Shipment of Solidified Resins in the RT-100 Cask

Public Meeting
November 17, 2015

RT-100 Shielding Analysis

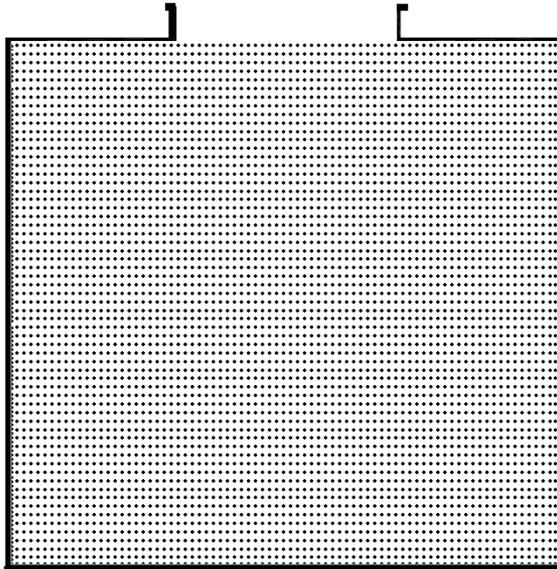
Operational changes for shipments of solidified resins:

SAR CH 7.6 provides additional information for the operation of the cask. Minor revisions to this section may be required to provide clarity and ensure compliance with the dose rate regulations. Revised steps below with changes marked:

1. The maximum **radioactive** content density is 1.0 g/cm^3 . The weight of free water **and any polymer binding material** must be excluded in this determination. The source strength density, **prior to the addition of any polymer binding agent**, must be ensured at any point of the content. Average density by dividing the total activity by total weight is not acceptable.

3. The weight of water **and any solidifying polymer material** must be excluded when determining the Ci/gram of content limit.
9. The radioactive content, **prior to the addition of any solidifying polymer binding agent**, is not to exceed 1.0 g/cm^3 and the nuclear physical characteristics, i.e., the gamma attenuation coefficient of the content must not be smaller than that of the carbon material resin. **An increase in the overall content density to a value greater than 1.0 g/cm^3 solely due to the addition of non-radioactive polymer binding material is acceptable.**

Model for Solidified Resins (Proposed)

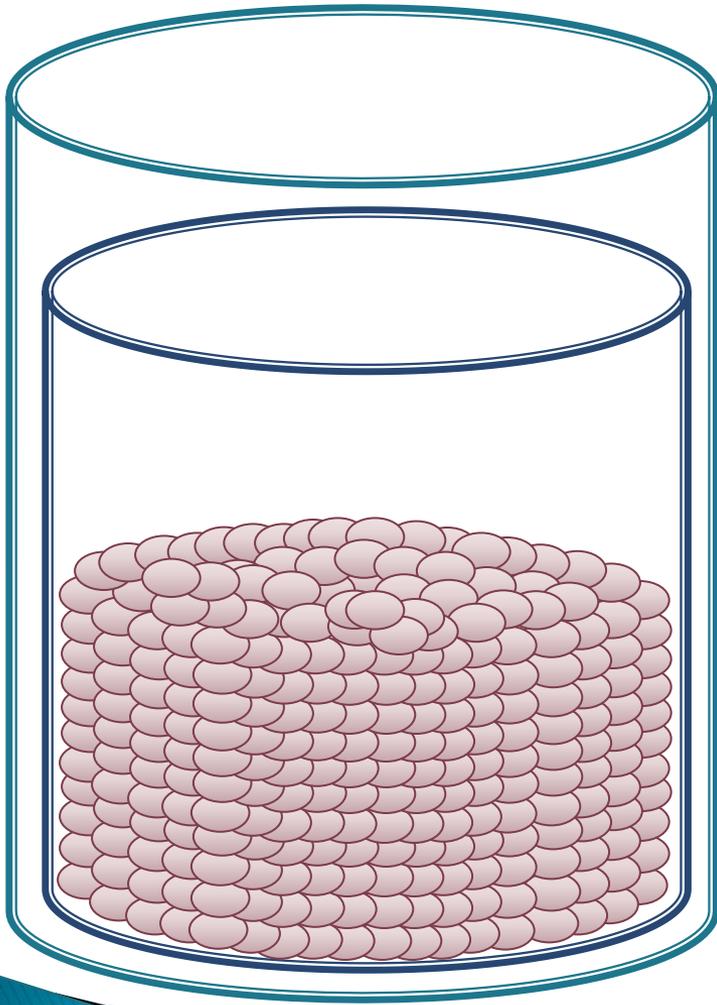
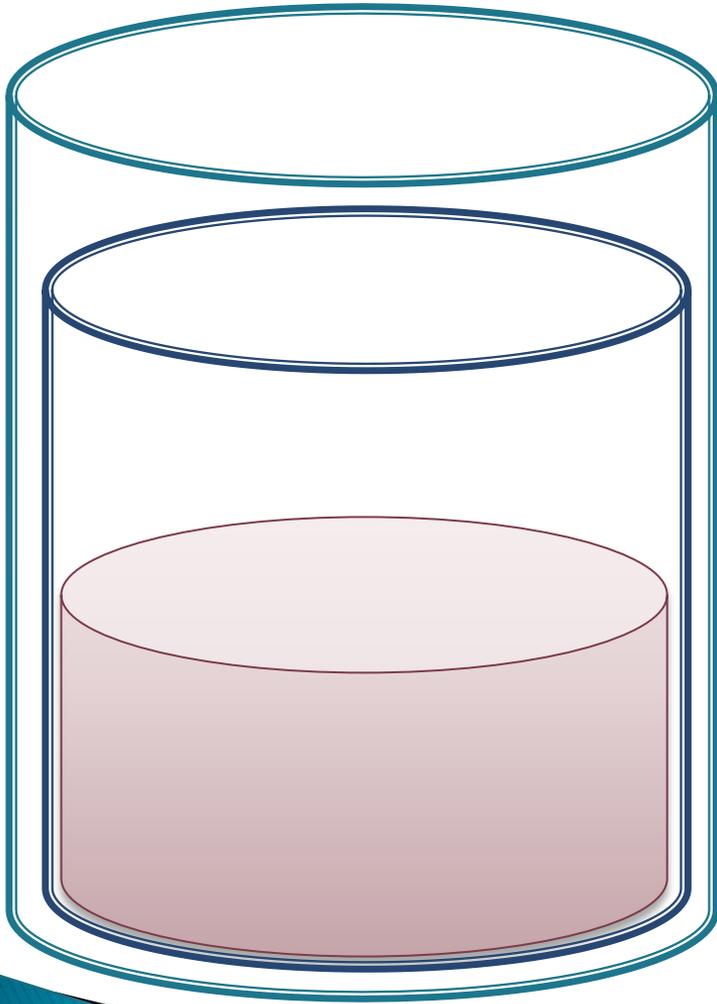
- ▶ RT-100 Inner Cavity Capacity
 - 162.37 ft³
- ▶ Volume occupied by Liner & Shoring
 - 30.10 ft³
- ▶ Remaining volume
 - 132.27 ft³
- ▶ Waste Volume (V_{WASTE})
 - 63.36% Ionic Resin ($G_T = 1.59$)
 - 25.75% Water ($G_T = 0.68$)
 - 10.89% Air
- ▶ Liner Type
 - Limited to liners listed in SAR Table 4.4.3-6
 - May be polyethylene ($G_T = 5.06$) or steel (not radiolytic)
 - When using the simplified loading curve, waste volume is limited to 130 ft³

- ▶ RT-100 Inner Cavity Capacity
 - 162.37 ft³
- ▶ Volume occupied by Liner & Shoring
 - 4 ft³ Liner
 - 6 ft³ Shoring (approximate)
- ▶ Remaining volume
 - 152.37 ft³
- ▶ Waste Volume (V_{WASTE})
 - 63.36% Ionic Resin ($G_T = 1.59$)
 - 01.00% Water ($G_T = 0.68$)
 - 35.64% AP ($G_T = 0.59$)
 - 00.00% Air
- ▶ Liner Type
 - Typically L-92 (steel)
 - Maximum waste volume = 92 ft³

- ▶ Solidified resins are stored in a smaller container
 - More air volume for hydrogen gas to expand into
- ▶ Solidified resins are stored in a steel container
 - Steel is not radiolytic, like polyethylene
- ▶ Water is replaced by Advanced Polymer
 - Advanced Polymer has a lower G-value than water
